# UNITED STATES PATENT AND TRADEMARK OFFICE

10/578,028

<b>Office Action Summary</b>	<b>Application No.</b> 10/578,028	<b>Applicant(s)</b> SHIN ET AL.	
	<b>Examiner</b> THANH-NHAN P. NGUYEN	<b>Art Unit</b> 2871

## DETAILED ACTION

**FIG.3**

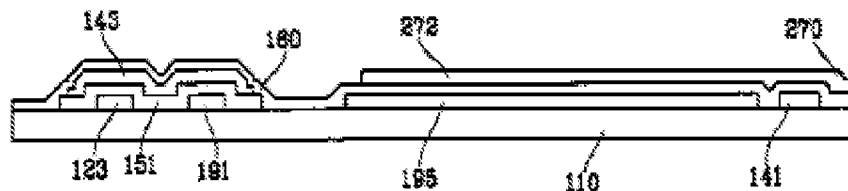
Oh et al disclose (Figs. 2 and 3) a thin film diode array panel comprising:

- an insulating substrate (110)
- first redundant gate lines (141) including a first input electrode (123) and made of an opaque conductor
- second redundant gate lines (142) including a second input electrode (124) and made of an opaque conductor
- first and second contact electrodes (191 and 192) formed on the insulating substrate and made of an opaque conductor

- an insulating layer (151, 152) formed on the first and second input electrodes and the first and second contact electrodes
- a first floating electrode (143) formed on the insulating layer (151) and overlapping the first input electrode (123) and the first contact electrode (191)
- a second floating electrode (144) formed on the insulating layer (152) and overlapping the second input electrode (124) and the second contact electrode (192)
- a pixel electrode (190) connected to the first and second contact electrodes

Oh et al lack disclosure of a first gate line formed at least partially directly on the first redundant gate line; a second gate line formed at least partially directly on the second redundant gate line.

However, it was well known in the art to form a first gate line formed at least partially directly on the first redundant gate line; a second gate line formed at least partially directly on the second redundant gate line, or in other words, to form double-layered (or multi-layered) gate line for the benefit of preventing the corrosion.

Therefore, at the time the invention was made, it would have been obvious to a person of ordinary skill in the art to form a first gate line formed at least partially directly on the first redundant gate line; a second gate line formed at least partially directly on the second redundant gate line for the benefit of preventing the corrosion.
